AN Plant Layout

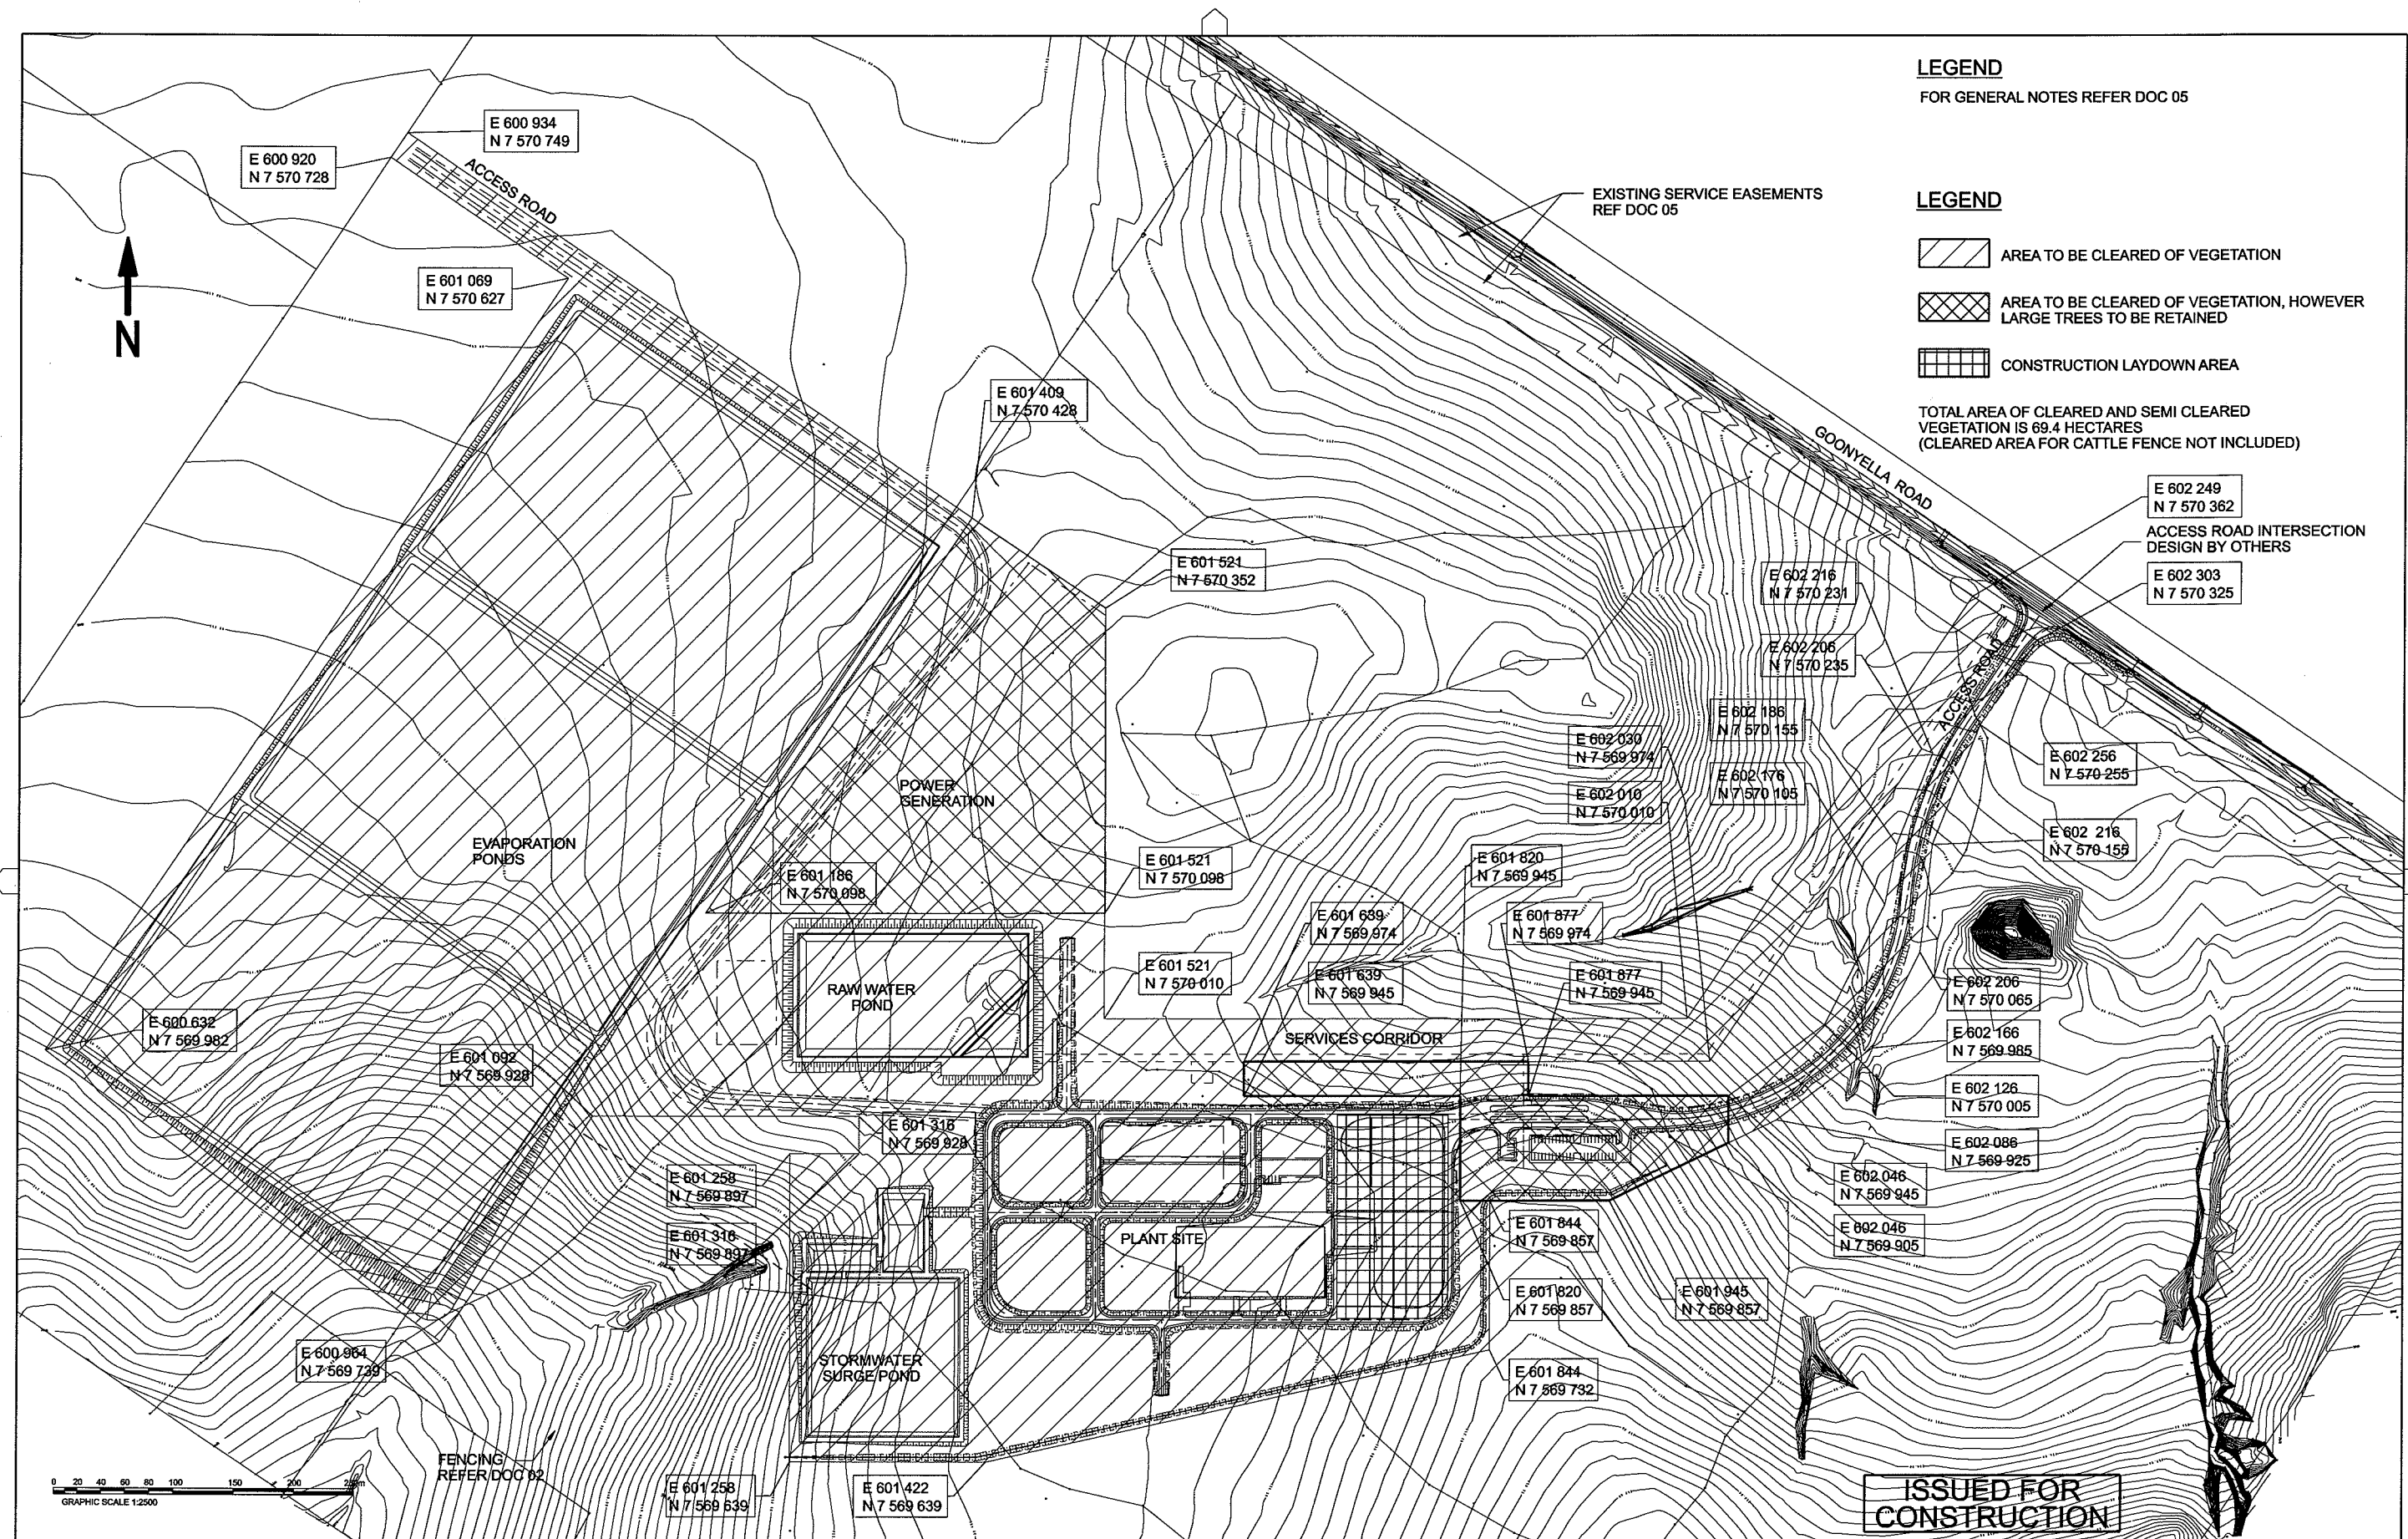
DoT 2: - The last paragraph on Page 50 is poorly worded and confusing. The sentence, "A separate access track from Goonyella Road will be constructed to reduce traffic demand on the external transport network", seems to be misleading. The separate direct driveway access to the construction camp (by itself) would mainly reduce internal traffic pressure and congestion at the main project site entrance A better description may be as follows:

EP11: - The EMP needs to contain a contingency plan to prevent or further reduce the likelihood of overtopping. For example, when the dam reaches 80% capacity, actions such as work cessation or removal of water to other locations (such as mine pits) may need to be considered.

As provided in the response from the Department of Transport a separate internal access road has been incorporated within the design for the project (refer Appendix B drawing no 600001-272-3y71-0003).

The AN Plant has a compartmentalised evaporation pond with 3 separate internal bunds with gravity flow between these ponds for maximisation of evaporation (see Appendix B, drawing number 600001-272-3y71-0003). The potential for overtopping to occur is very low based on the existing water balance that has been undertaken that demonstrates that there is no overtopping of the evaporation ponds based on the available historical data for this part of Queensland. When the evaporation pond reaches 50% capacity DN will undertake an assessment on the management of the evaporation ponds based on actual operating data and identify measures required to manage the potential for overtopping once the evaporation ponds fill to 80% capacity. These measures may include:
